Product Change Notification

1. ECR #: 203784
Notification #: 574

- LSHM - 0.50MM TERMINAL/SOCKET COMBO

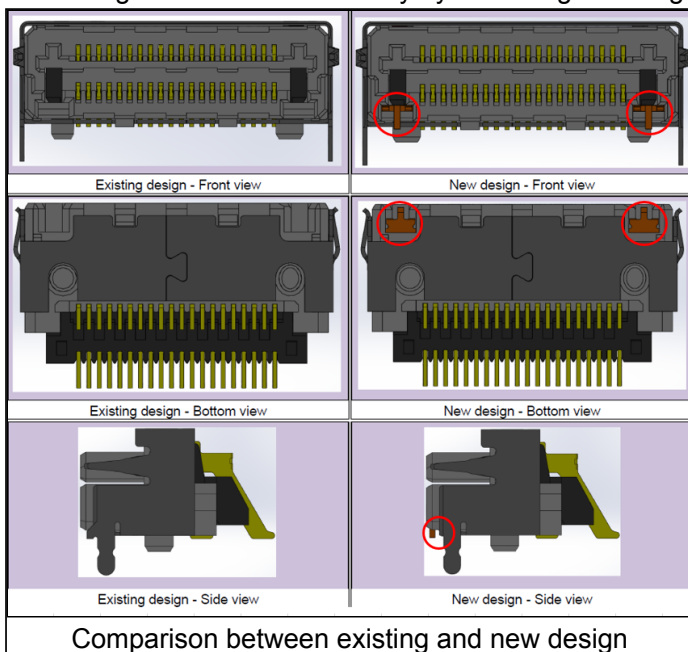
Adding metal tabs to the assembly on both sides and removing the feet from the shield.

The changes can be seen visually by reviewing the images below.

Improved soldering and coplanarity with no changes to coplanarity specifications or recommended PCB layout.
